**STAFF RECOMMENDATION**

1401 Roberts Avenue  
July 15, 2020

**Application:** New Construction—Outbuilding (Detached accessory dwelling unit)  
**District:** Eastwood Neighborhood Conservation Zoning Overlay  
**Council District:** 06  
**Base Zoning:** R6  
**Map and Parcel Number:** 08301034200  
**Applicant:** Cheyenne Smith  
**Project Lead:** Paul Hoffman, paul.hoffman@nashville.gov

Figure 2: The DADU as proposed is lower than the house due to the grade but is not subordinate to the primary building as measured from finished floor height.

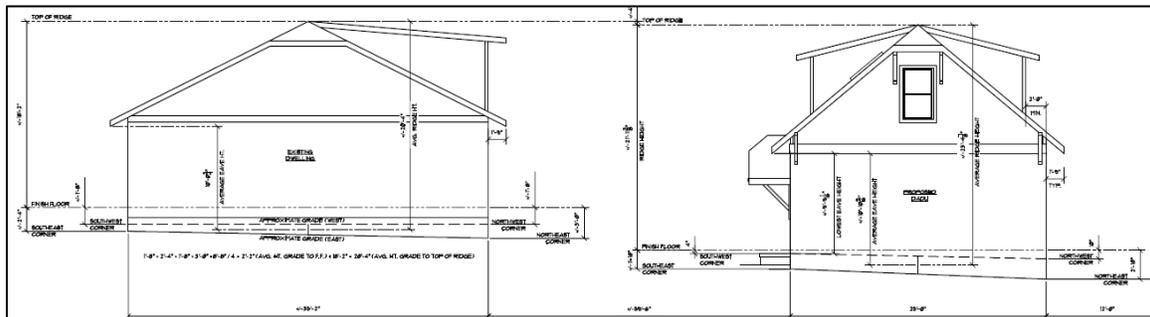
Because of variations in grade, the Commission has determined that the eave and ridge height measurements of the historic house should be taken from the top of the foundation and/or finished floor line. The ridge height of the primary building is eighteen feet, two inches (18' 2") from the finished floor, and the eave height is ten feet (10'). The proposed ridge height of a DADU is typically measured from grade because outbuildings are typically constructed on a slab. Because of varying grade, this DADU has a foundation instead of a slab, so the measurement was taken from the finished floor in order to ensure that the comparison to the historic building was proportional. The proposed DADU is twenty-one feet, eleven inches (21' 11") from the finished floor height, and the eave height is ten feet, ten inches (10' 10"), both of which exceed the corresponding height on the house.

In this case, as the outbuilding exceeds the height of the primary building as measured to the ridge and the eave, staff recommends that the overall height be reduced to eighteen feet, two inches (18' 2"), and the eave height be reduced to ten feet (10'), so as not to exceed the height of the house.

1. That the ridge height is reduced to be no taller than eighteen feet, two inches (18' 2"), and the eave height reduced to no taller than ten feet (10'); and,
2. Staff approve the masonry, windows, doors and garage doors prior to purchase and installation.

SCALE: 1/4" = 1'-0"  
 A100  
 SITE PLAN AND  
 HEIGHT COMPARISON

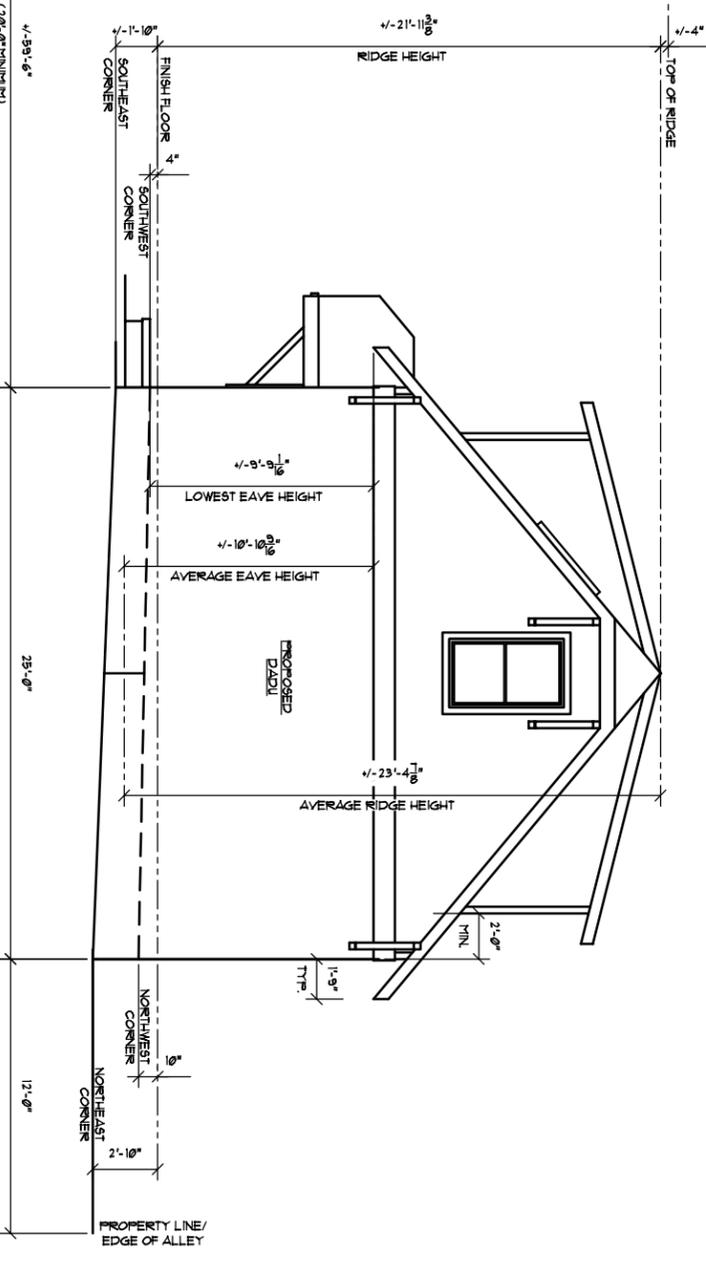
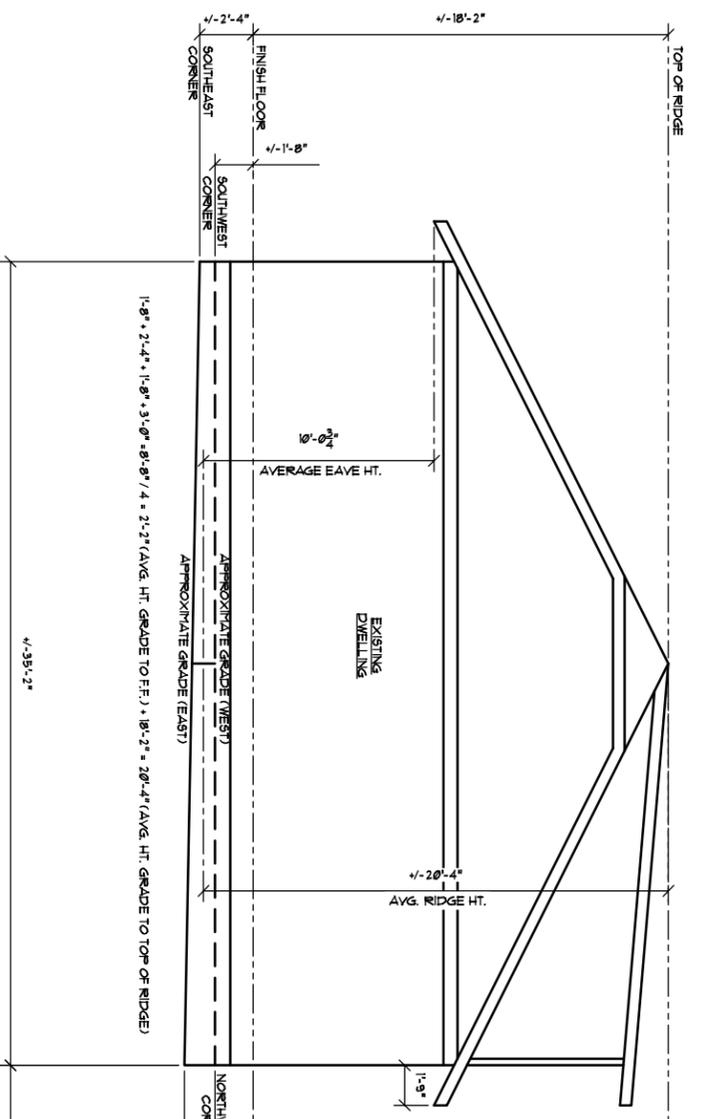
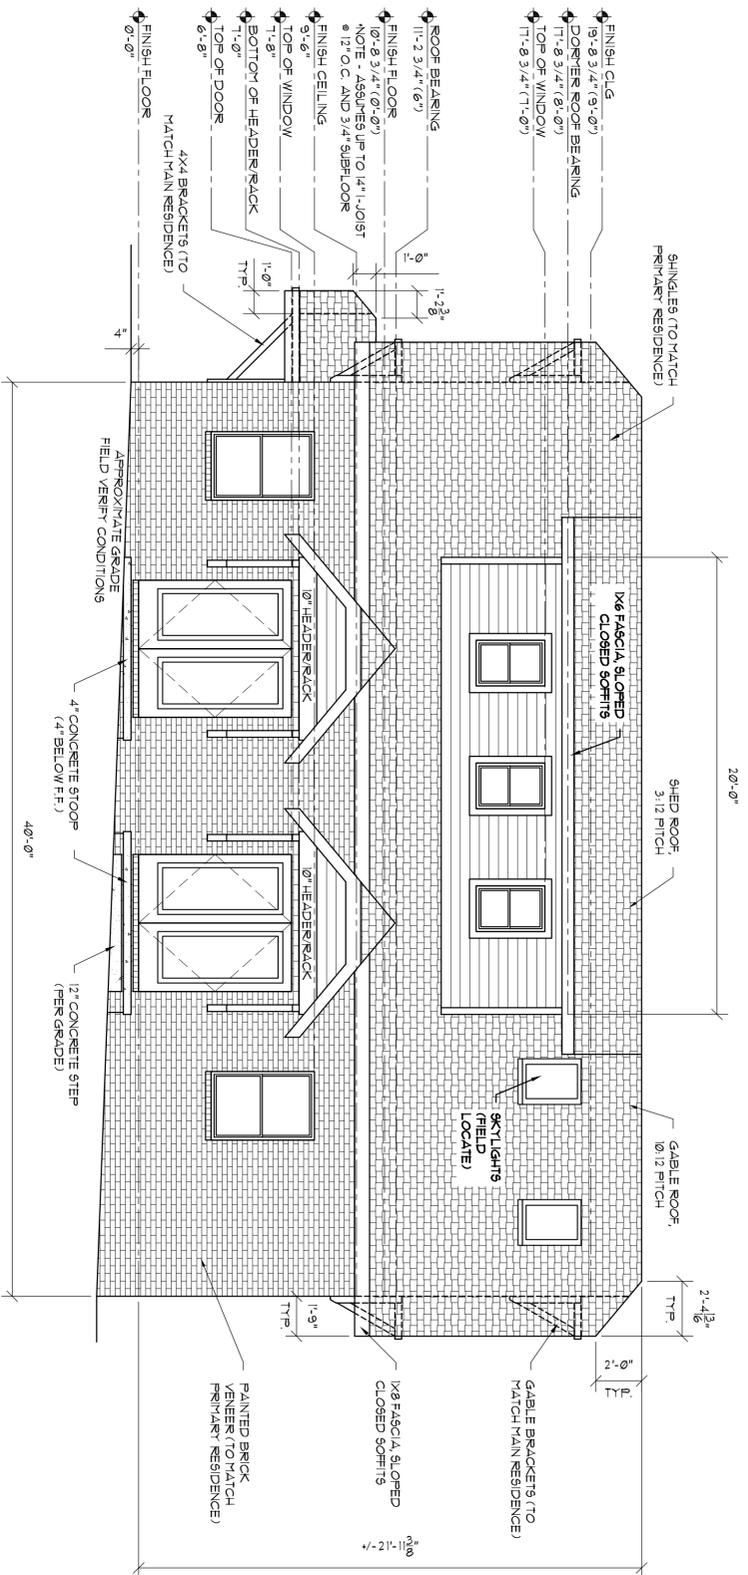
<b>MINIMUM</b>	<b>PROPOSED</b>
<b>Building located towards rear of lot</b>	-	Yes
<b>Space between principal building and Garage</b>	20'	~59'
<b>Rear setback</b>	5'	12'
<b>L side setback</b>	5'	5'
<b>R side setback</b>	5'	~16'
<b>How is the building accessed?</b>	-	From alley
<b>Two different doors rather than one large door (if street facing)?</b>	-	N/A

EXTERIOR ELEVATIONS

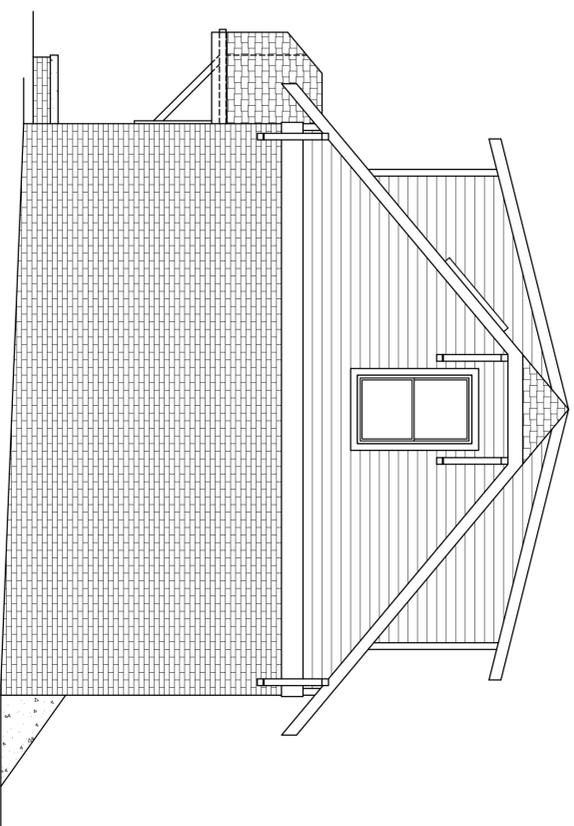
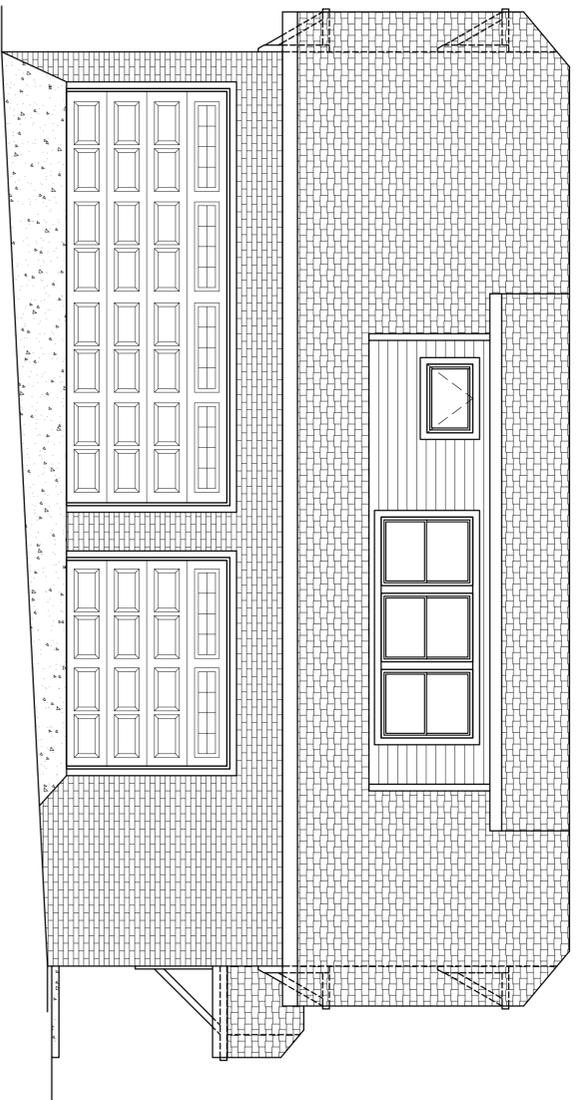
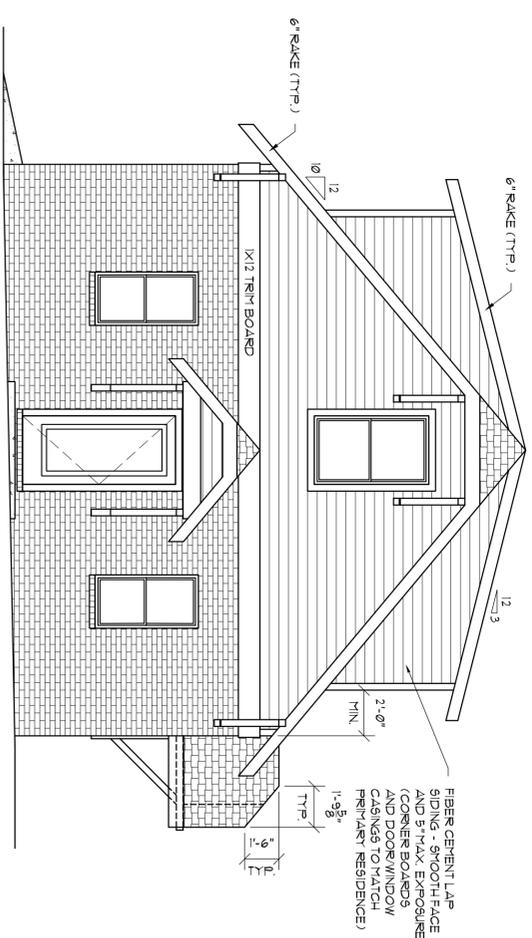
The proposed dormers inset two feet (2') from the wall below them and they are twenty feet in width, which is fifty percent (50%) of the roof width.

<b>Proposed</b>	<b>Color/Texture/Make/Manufacturer</b>	<b>Typical of Neighborhood</b>	<b>Requires Additional Review</b>
<b>Foundation</b>	Brick	Unknown	Yes	Yes
<b>Cladding</b>	Brick	Unknown	Yes	Yes
<b>Secondary cladding</b>	Lap siding	Smooth-face, 5" reveal	Yes	No
<b>Roofing</b>	Architectural shingles, asphalt	Match house	Yes	No
<b>Trim</b>	Wood or fiber cement boards	Smooth	Yes	No
<b>Windows</b>	Not indicated	Not indicated	Unknown	Yes
<b>Pedestrian Door</b>	Not indicated	Not indicated	Unknown	Yes
<b>Garage Door</b>	Not indicated	Not indicated	Unknown	Yes

With staff's final approval of the masonry, windows, doors and roof shingle color, staff finds that the materials meet the design guidelines.
